Docket Number:	15-AFC-01
Project Title:	Puente Power Project
TN #:	213649
Document Title:	Dr. Fox Comments on Puente PDOC and PSA (7-29-16)
Description:	N/A
Filer:	PATRICIA LARKIN
Organization:	SHUTE, MIHALY & WEINBERGER LLP
Submitter Role:	Intervenor Representative
Submission Date:	9/14/2016 4:31:10 PM
Docketed Date:	9/14/2016

Comments
on the
Puente Power Project
Ventura County APCD
Preliminary Determination of Compliance
and
California Energy Commission
Revised Preliminary Staff Assessment

July 29, 2016

Phyllis Fox, Ph.D., PE
745 White Pine Ave.
Rockledge, FL 32955
phyllisfox@gmail.com
321-626-6885

Figure 1: Comparison of PM_{2.5} as Reported in AP-42 with Recent Measurements Using Improved Testing Methods.⁵²

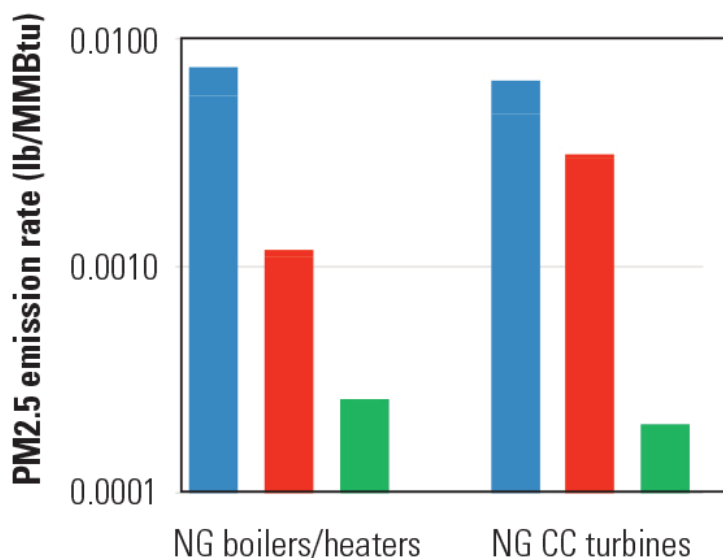
Figure 1 compares the results of these studies with AP-42 emission factors, relied on by the Applicant to establish the baseline. This figure shows that AP-42 emission factors

overestimate actual baseline emissions by significant amounts compared to modern testing methods.

The results of these investigations for gas-fired boilers and steam generators, such as MGS Unit 2, are summarized in Table 3. These revised emission factors have been used in EPA National Emission Inventories and to permit new sources.⁵³ The revised PM_{2.5} emission factor for gas-fired boilers and steam generators (0.35 lb/MMscf⁵⁴) is a factor of seven lower than the AP-42 emission factor of 2.5 lb/MMscf used in the Applicant's PM_{2.5} netting analysis.⁵⁵ Using

this revised PM2.5 emission factor but otherwise using the Applicant’s assumptions, yields a net change in PM2.5 emission of **10.4 ton/yr**.⁵⁶ This change alone results in an exceedance of the PM2.5 significance threshold and triggers PSD review for PM2.5.

Figure 2: Monthly NOx and Fuel Use 2009-2014
(gas flow units in 100 scf/mo)

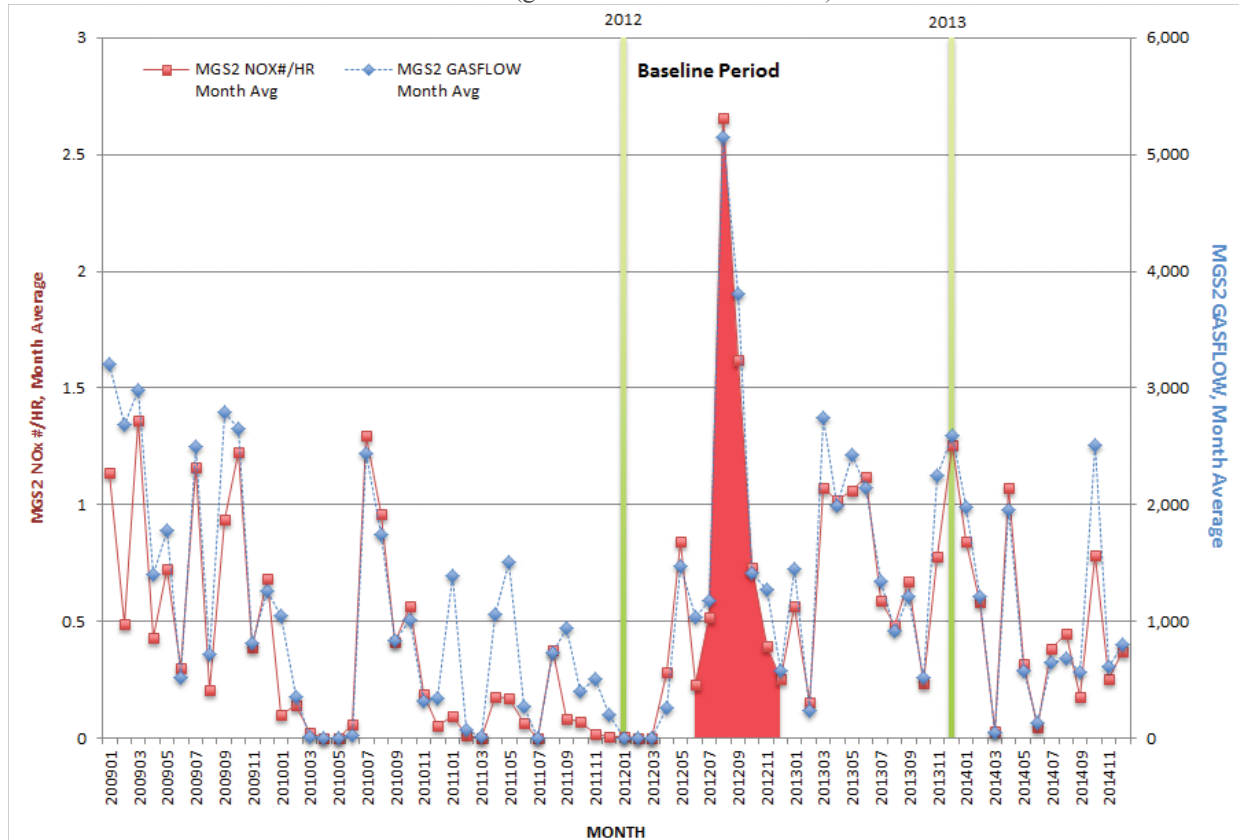
My analysis of the applicant’s NOx and fuel use CEMS data, summarized in Figure 2, indicates that the 2012-2013 period selected as the baseline is not representative of normal

operation. In fact, it is the two year period that yields the highest baseline emissions for all pollutants, rather than representative baseline emissions.

First, the 2012-2013 period includes a very large spike in August and September of 2012.⁶⁵ A similar spike is not found elsewhere in the record.

Second, my analysis of this data, summarized in Table 4, indicates that the Applicant picked the two year period that yields the lowest net change in PM2.5 emissions from among the four possible consecutive two-year combinations (10.0, 9.63, **9.06**, 9.27 ton/yr). It is not apparent how a spike in fuel use and emissions, including many violations of permit limits⁶⁶ as discussed in Comment section II.B.2.c.ii satisfies VCAPCD Rule 26.6C.

Figure 3. Hourly PM_{2.5} Emissions from MGS Unit 2.⁷¹

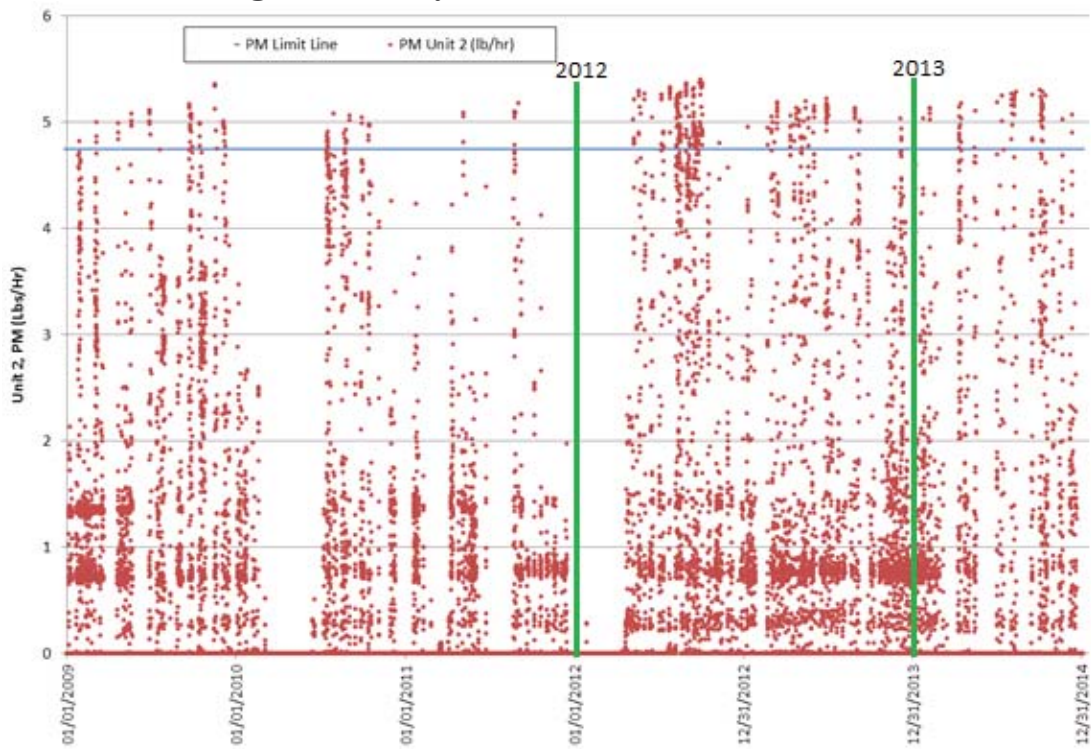
Further, MGS Unit 2 is permitted as a Babcock & Wilcox natural gas steam generator with a maximum heat input of 1990 MMBtu/hr.⁷² The Applicant's CEMS data also indicates that the unit operated at higher maximum heat inputs during the baseline period.
